DISPUTE RESOLUTION CASE CONSIDERED BY SESBSC Group: 3 October 2018

Decision of Local Consortium and Initiating Authority – Case Closed

SECTION B-B - PROPOSED Scale: 1:50

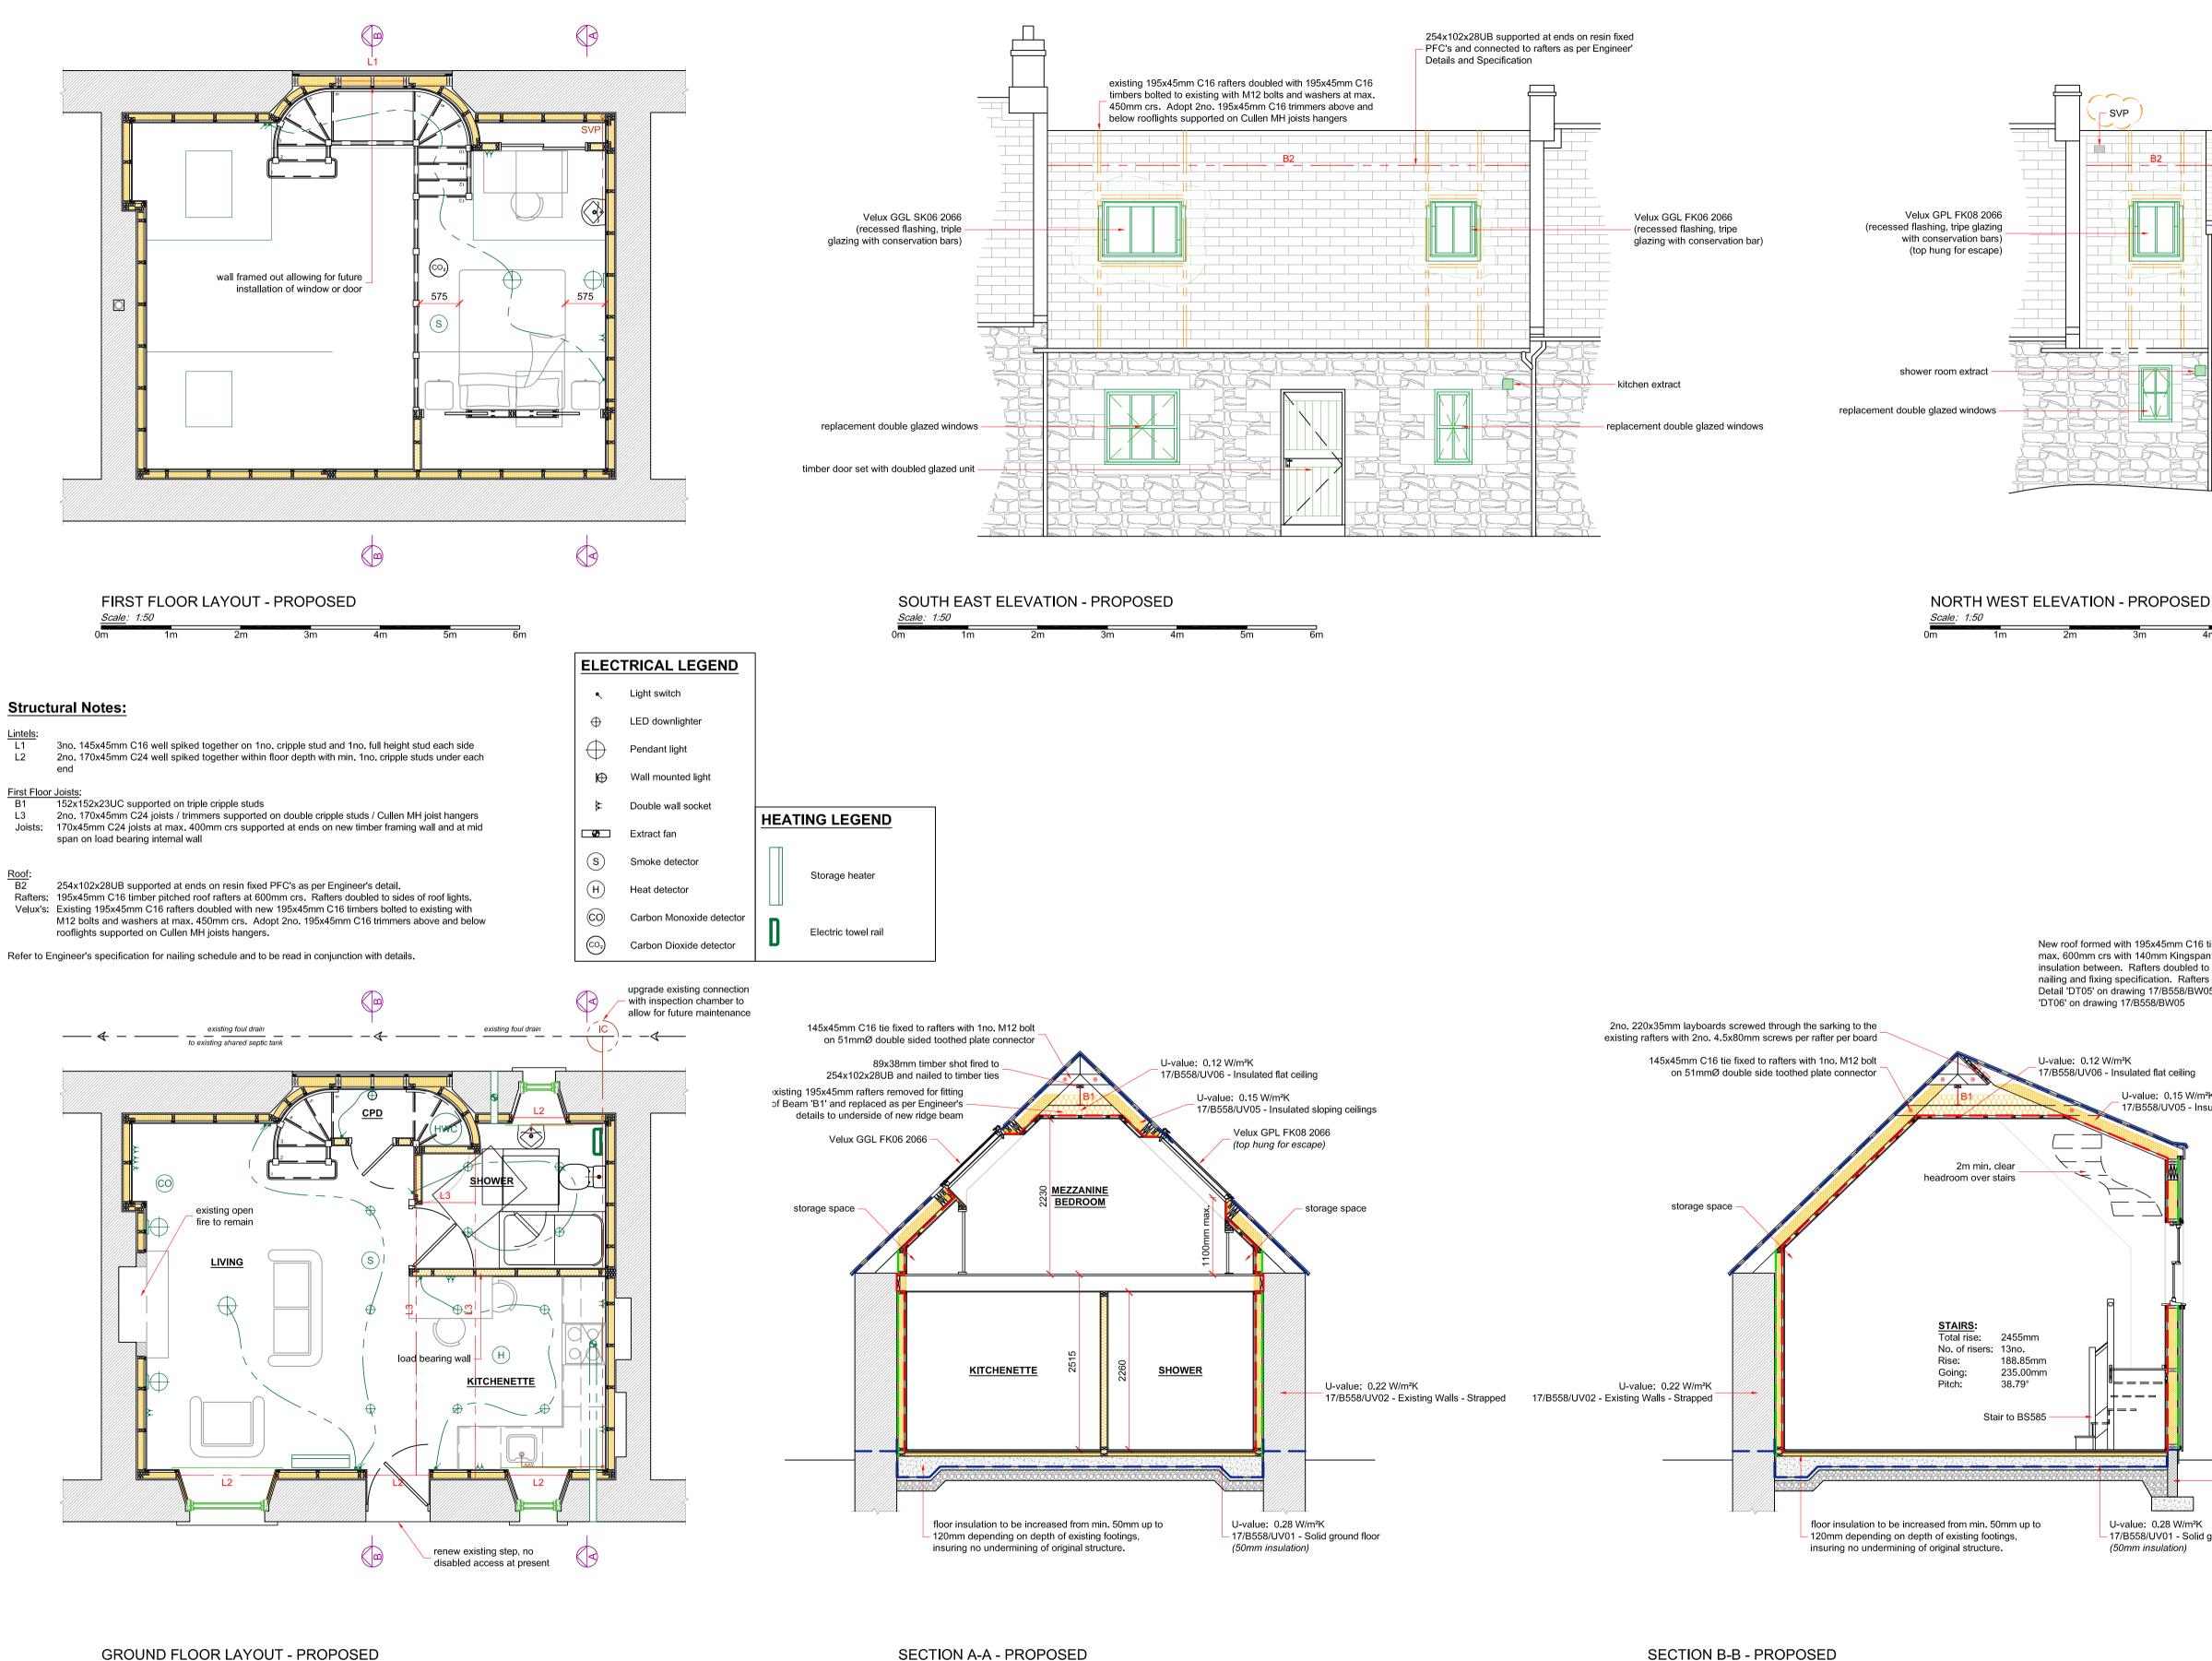
Following receipt of your dispute resolution application for the above project, the South East Technical Consortia Group were consulted on the 16th August 2018 with responses being received from West and Midlothian Council on the 17th August and from East Lothian and Edinburgh City Council on the 24th August confirming that in this instance they would not request that the intermediate floor be upgraded to achieve the 43dB sound insulation, where the first floor apartment is open planned to the living room and kitchen.

In this case, Scottish Borders Council have agreed to follow the consensus of the consortia group and accepted that the intermediate floor in this case does not require the sound insulation as set to guidance in 5.2.1 Design performance level & 5.2.3 Intermediate floors of the Domestic Technical Handbook.
